**HIGH DESERT
POWER PROJECT, LLC**

**RE: High Desert Power Project, LLC
Docket No. 97-AFC-1,
Petition for Modification to Use Reclaimed Water
Response to October 29, 2008 Data Requests**

**High Desert Power Project, LLC
Response to California Energy Commission
October 29, 2008 Data Requests**

Figure 1
Site Layout
January 28, 2009

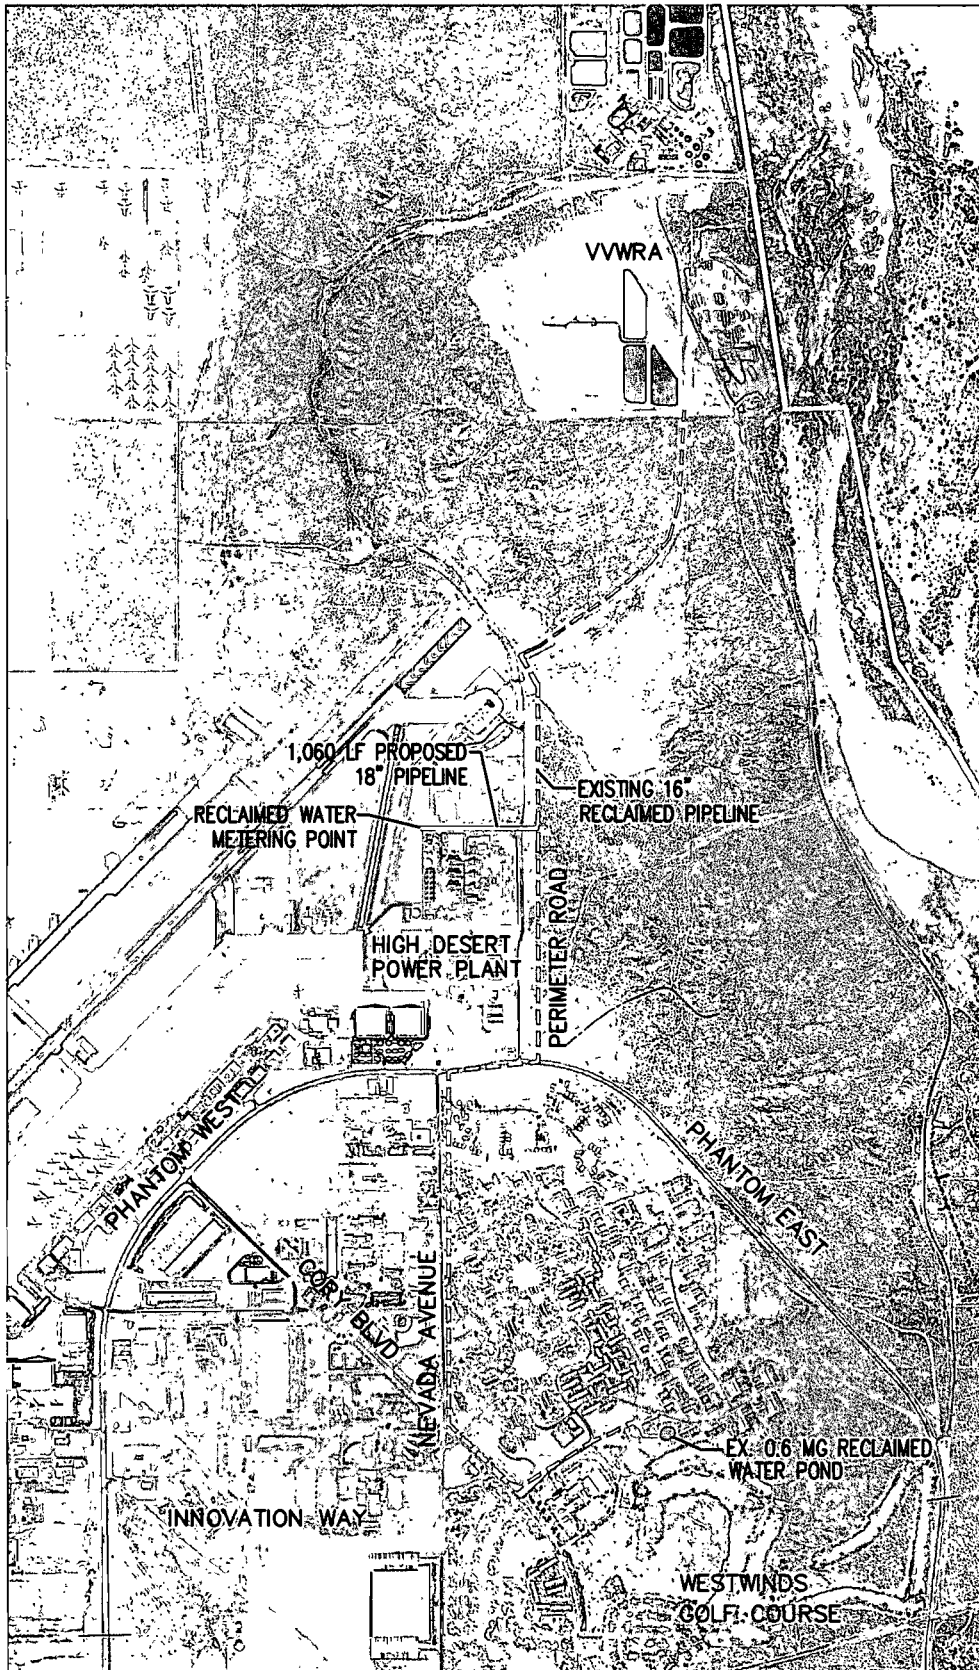
(3) Please identify what equipment, construction and permits will be required to provide recycled waste water to the facility.

Tertiary-treated reclaimed water will be pumped via buried pipeline to the HDPP facility from the Victor Valley Water Reclamation Authority (“VVWRA”). An existing 16-inch diameter reclaimed water pipeline from VVWRA is in-place on the east side of the HDPP facility, along Perimeter Road. The City will build an 18-inch diameter, 1,060 lineal foot pipeline (the “City Pipeline”) from the existing 16-inch reclaimed water pipeline to the “Reclaimed Water Metering Point” located near the northwest corner of HDPP facility. The City will construct, own, and operate this new pipeline, and will acquire all necessary construction permits.

Please see Figure 1 for the location of the existing facilities and the improvements described above.

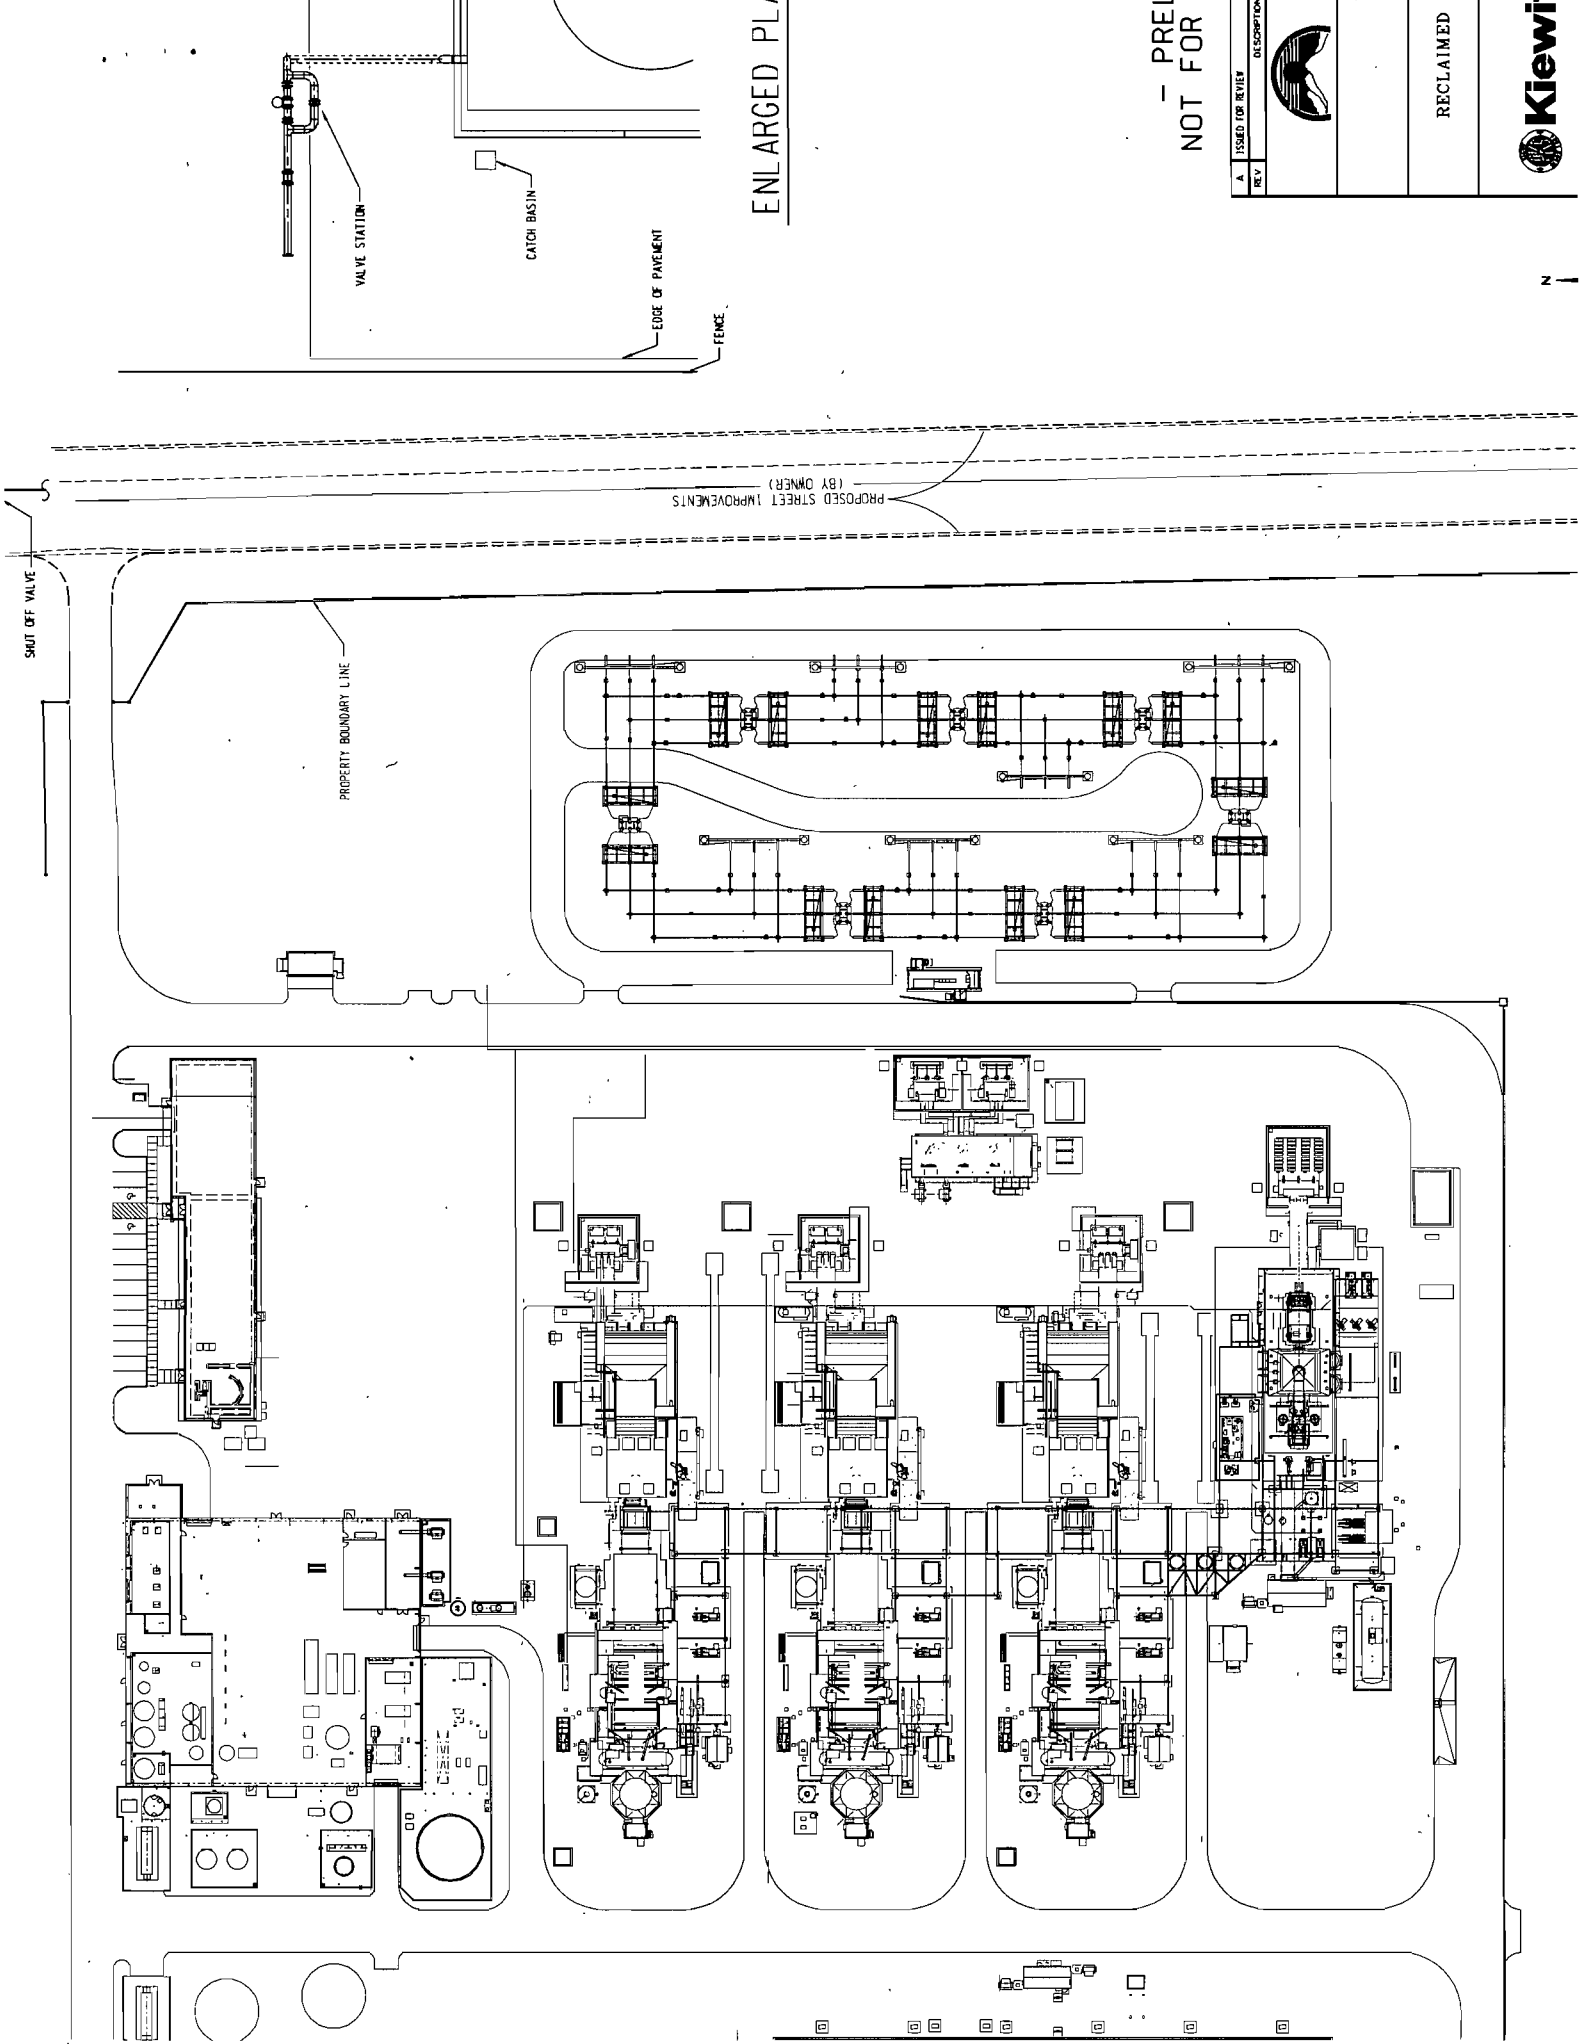
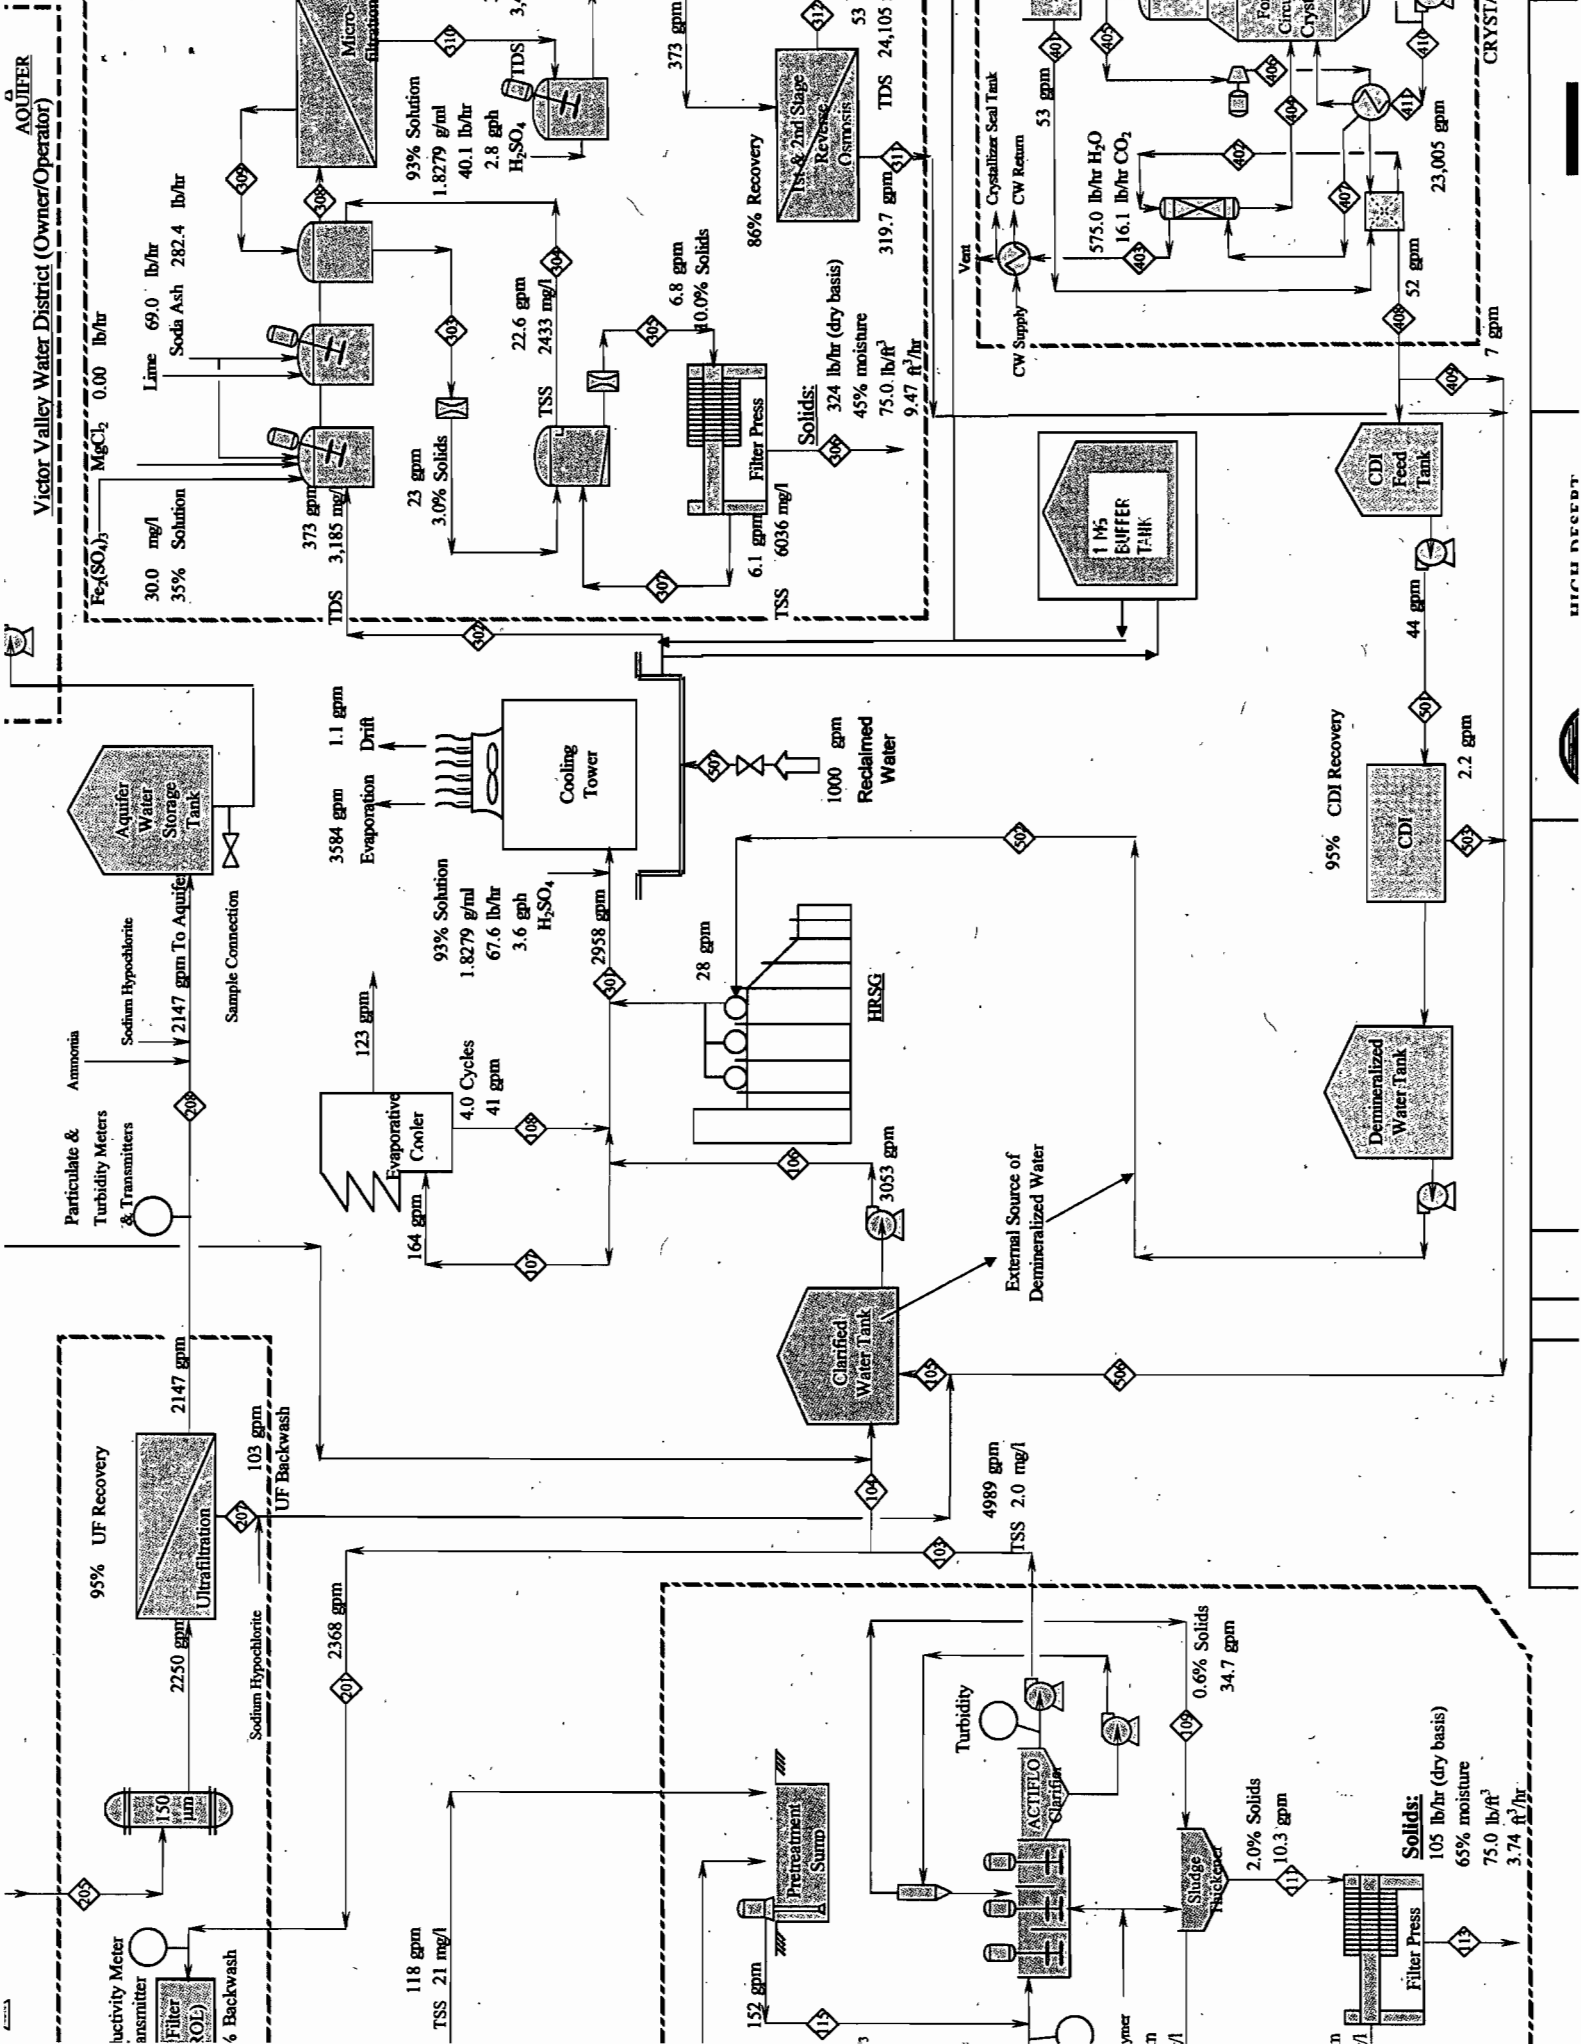
- (6) Please provide a schematic showing how recycled water will be incorporated into the current water supply system.**

- (7) **Please provide a schematic drawing for each of the water systems that include the water treatment method for each system.**

As depicted in Figure 3, reclaimed water will be directed into the cooling tower basin.

See Figure 3.
